ADDENDUM NO. 2

PROJECT NO. 39-16-01 (PART A) RIGHT TWO (2) LANES AND SHOULDER RECONSTRUCTION MILEPOST 107.3 TO MILEPOST 112.5 **ERIE COUNTY, OHIO**

PROJECT NO. 39-16-01 (PART B) BRIDGE DECK REPAIR & REHABILITATION OHIO TURNPIKE OVER NS RAILROAD AND KELLY ROAD MILEPOST 117.3 **OHIO TURNPIKE OVER US ROUTE 250 MILEPOST 118.1 ERIE COUNTY, OHIO**

ANSWERS TO QUESTIONS RECEIVED THROUGH 4:00PM ON DECEMBER 10, 2015 MODIFICATIONS TO THE CONTRACT DOCUMENTS

PROJECT 39-16-01A SHEET 20 of 432

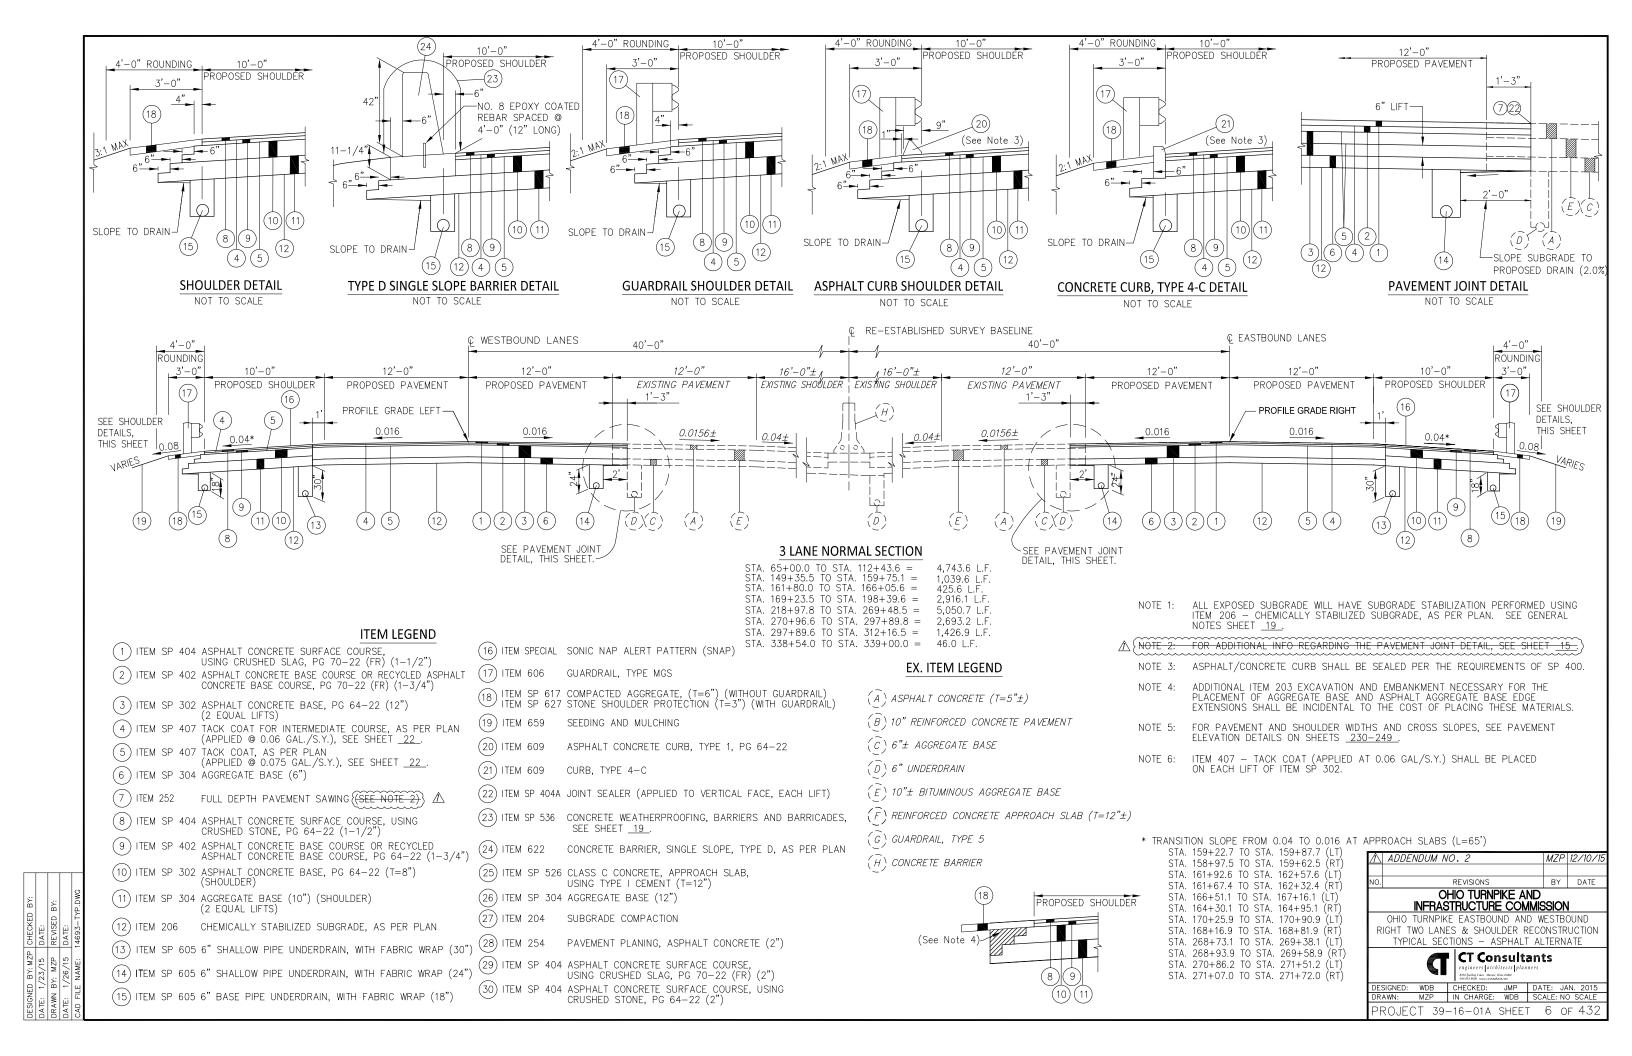
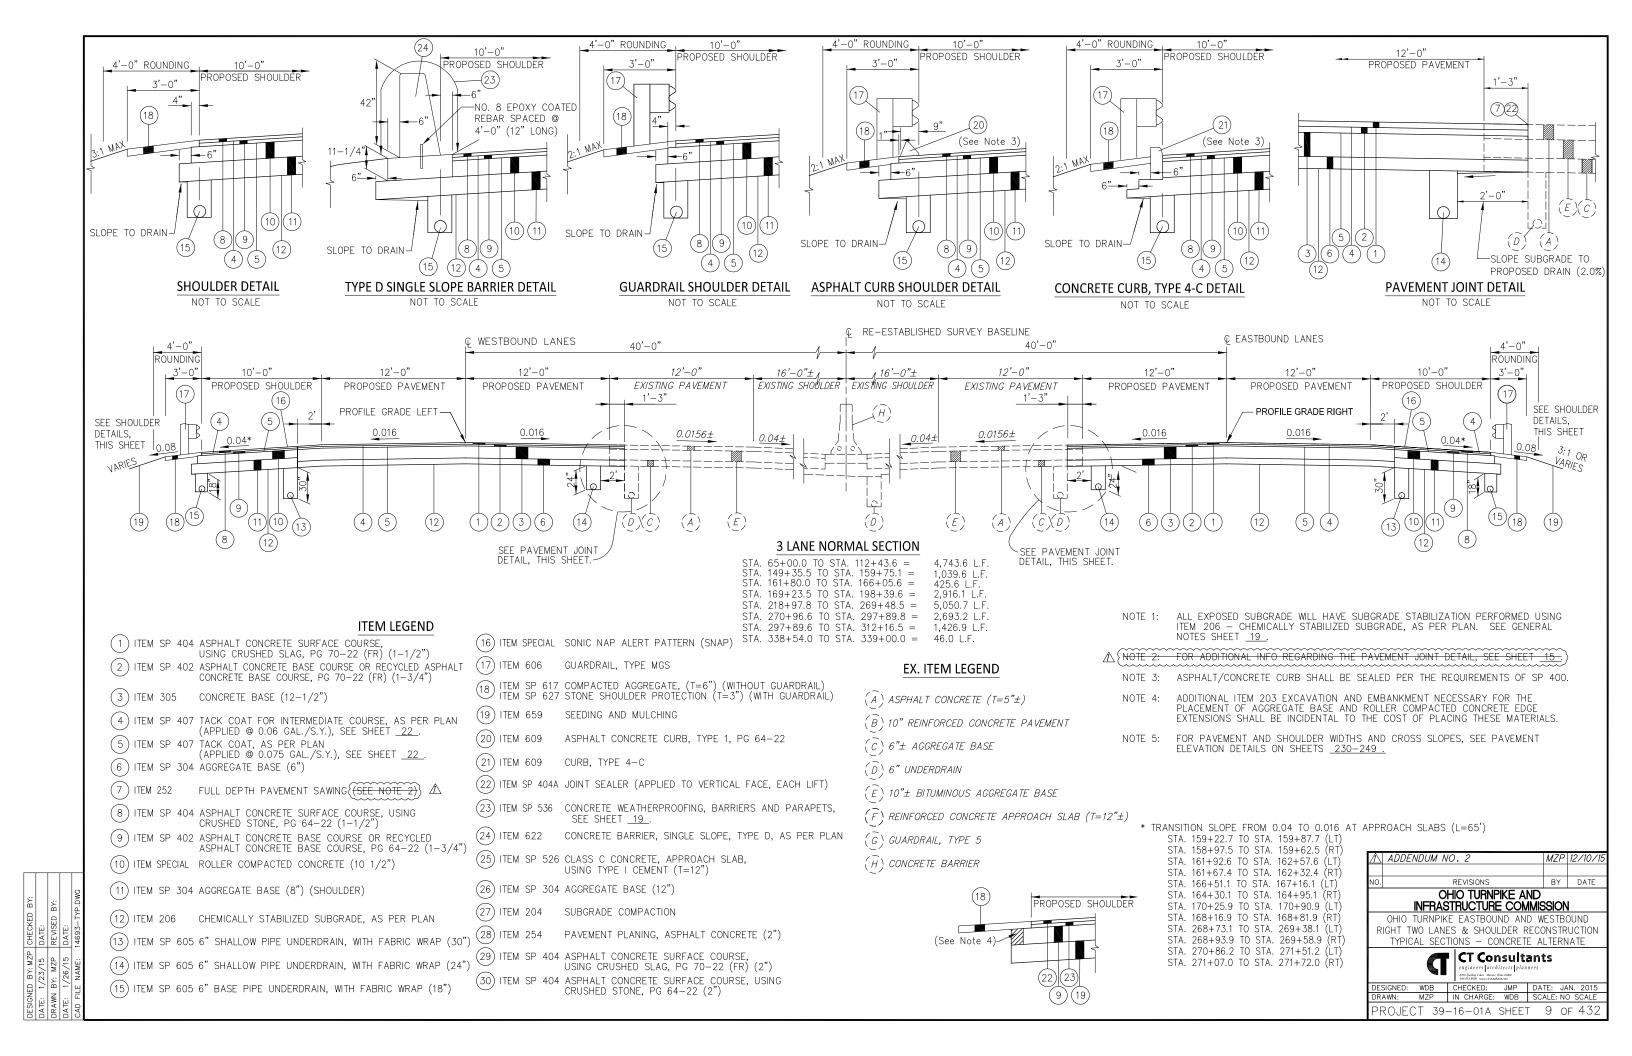
- Q#16 Plan sheet 20, under the 252 Full Depth Sawing note, refers to plan sheet 15 "condition 1". Plan sheet 6, note 2 (pavement joint detail), also says to refer to sheet 15. Sheet 15 shows only existing typical sections without any further information. Please review and revise these notes accordingly.

- A#16 This Addendum No. 2 modifies Plan Sheets 6, 9 and 20 of 432 to remove references to the Pavement Joint Detail on Sheet 15 of 432.

THIS ITEM SHALL ALSO BE USED BY THE ENGINEER TO SAW CUT THE EXISTING MAINLINE PAVEMENT AS OUTLINED IN THE CONDITION NO. 1 ON SHEET 15 OF THE PLANS.
